**National Interim Primary Drinking
Water Regulations; Control of
Trihalomethanes in Drinking Water;
Correction**

ACTION: Final Rule; Correction.

SUMMARY: This document corrects errors found in Federal Register Doc. 79-36442, appearing at page 68624 in the Federal Register of November 29, 1979. Included among the corrections are a completed description of an analytical methodology, additional discussion concerning the cost/benefit analysis and revised figures describing the extent of monitoring required.

FIGURE 1
CONSIDERATIONS FOR REDUCED MONITORING REQUIREMENTS
SURFACE WATER SYSTEMS

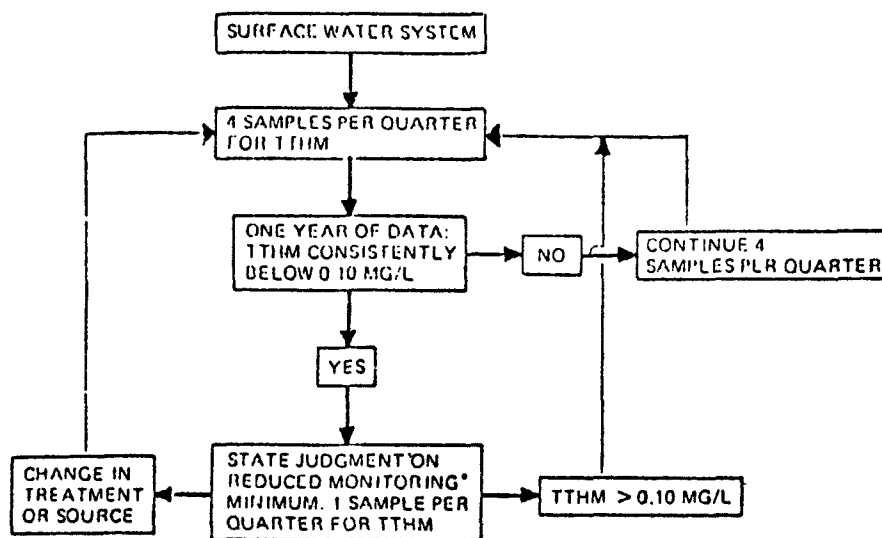
1. Page 68633—The existing Figure 1 should be replaced by the accompanying Figure 1, "Considerations for Reduced Monitoring Requirements, Surface Water Systems."

**FIGURE 2
CONSIDERATIONS FOR REDUCED MONITORING REQUIREMENTS
GROUNDWATER SYSTEMS**

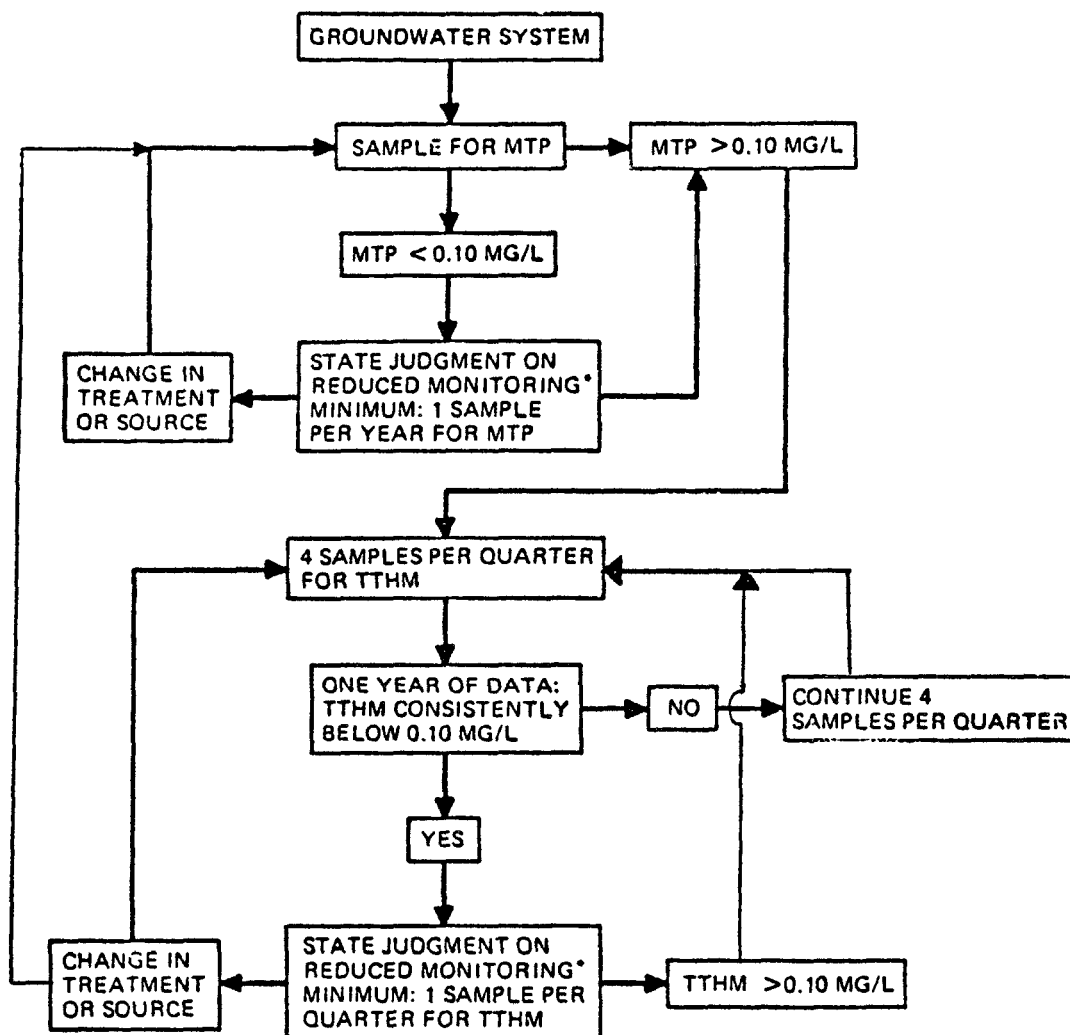
2. Page 68635—The existing Figure 2 should be replaced by the accompanying Figure 2, "Considerations for Reduced Monitoring Requirements, Groundwater Systems."

FIGURE 1 - BENEFIT VS. COST FOR TTHM REGULATION

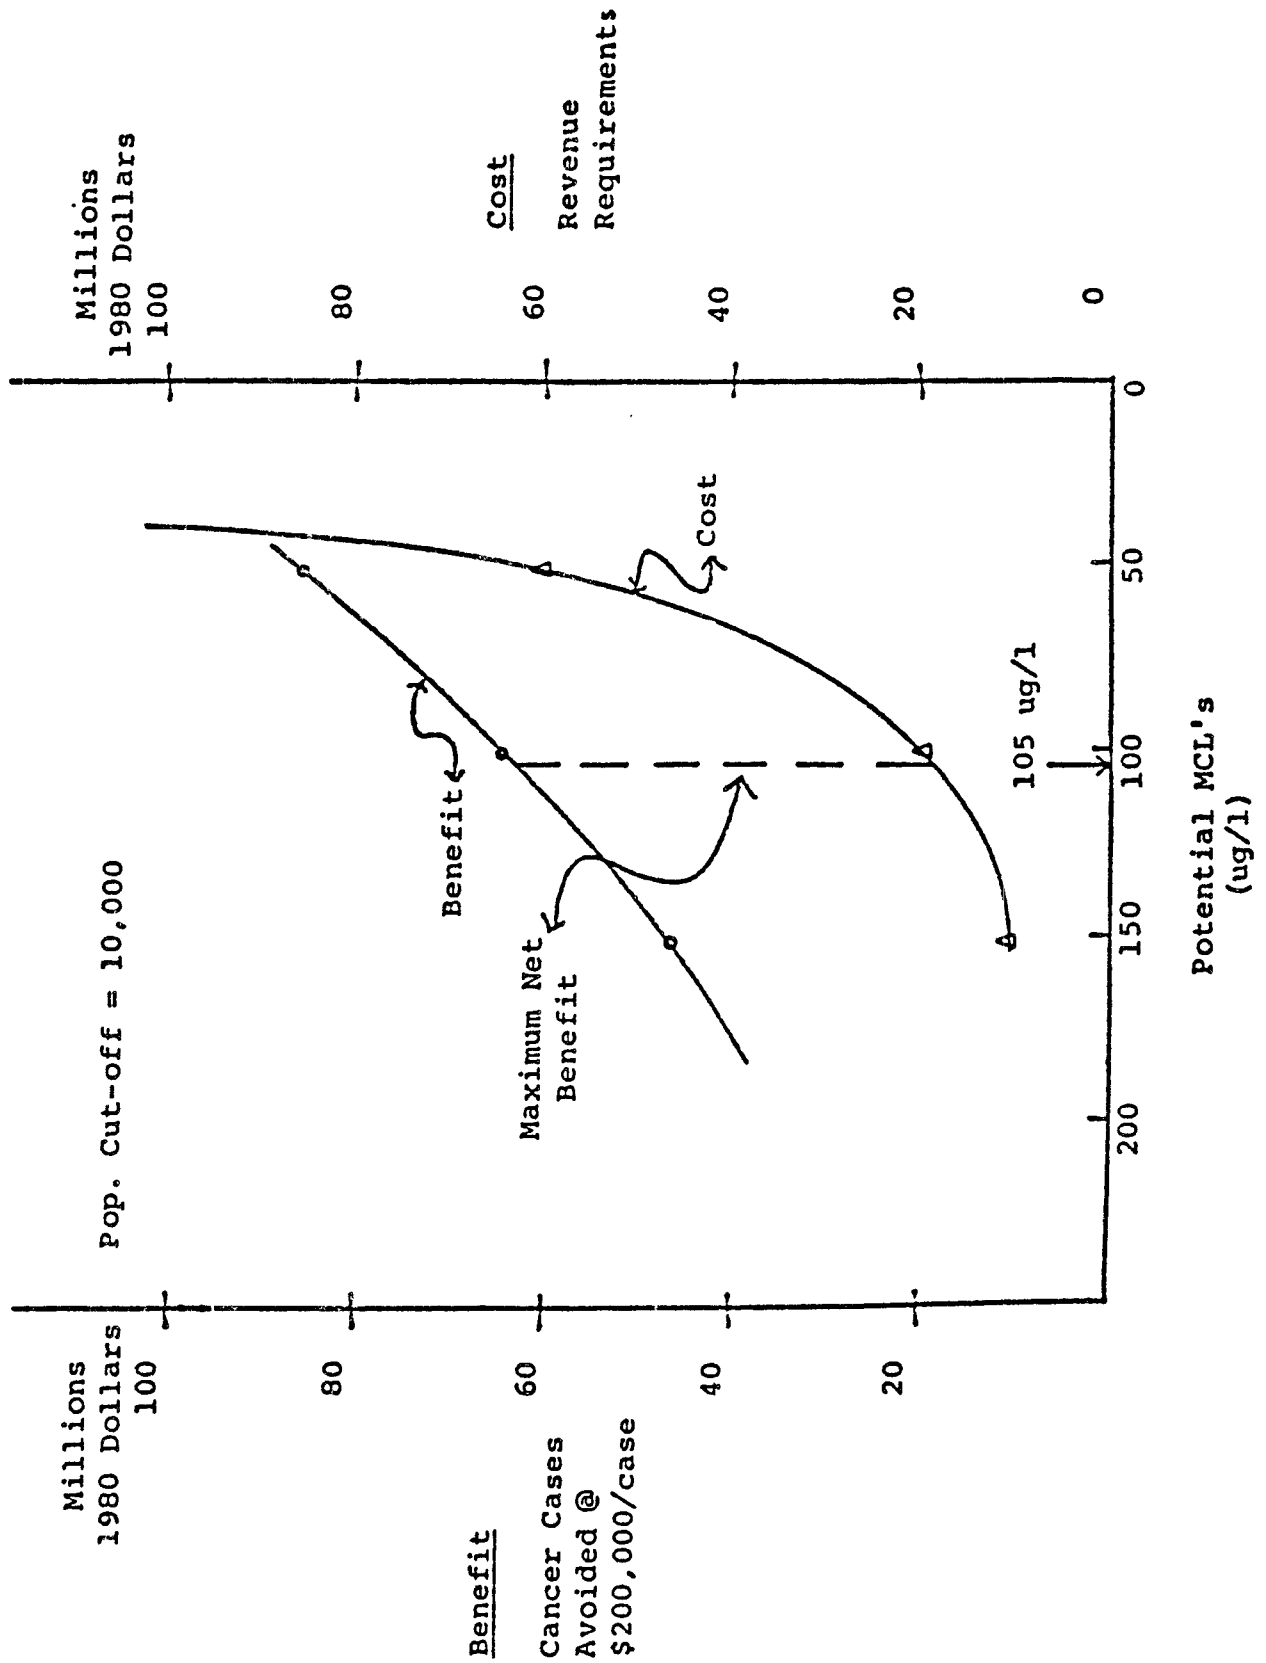
18. Page 68704—In the third column, add the following discussion and table (that were prepared prior to the Administrator's signing of the

regulations but inadvertently omitted from the Statement of Basis and Purpose) to the end of Title IX, "Risk Assessment":

"As indicated by NAS, the value of avoiding a cancer death has been estimated to be from \$10,000 to \$1.3 million. An often used estimate is \$200,000, a figure based upon both cost earnings and social value. EPA feels that benefit-cost analysis using this methodology is more sophisticated than the available data. In response to the CWPS comments, the methodology was used to develop Figure 1. This figure shows the benefits associated with three MCL alternatives, associating a value of \$200,000 per case using the best estimate of 322 cases avoided. The cost of the regulation alternatives, as discussed in the economic impact assessment, are also shown. The largest vertical distance between the benefit and cost curves represents the maximum net benefit. At this point, the greatest economic efficiency is achieved. This point corresponds to an MCL of 0.105 mg/l. This figure suggests that an MCL of 0.100 mg/l is clearly more economically efficient than other MCLs considered, based upon the most appropriate benefit and cost assumptions available."
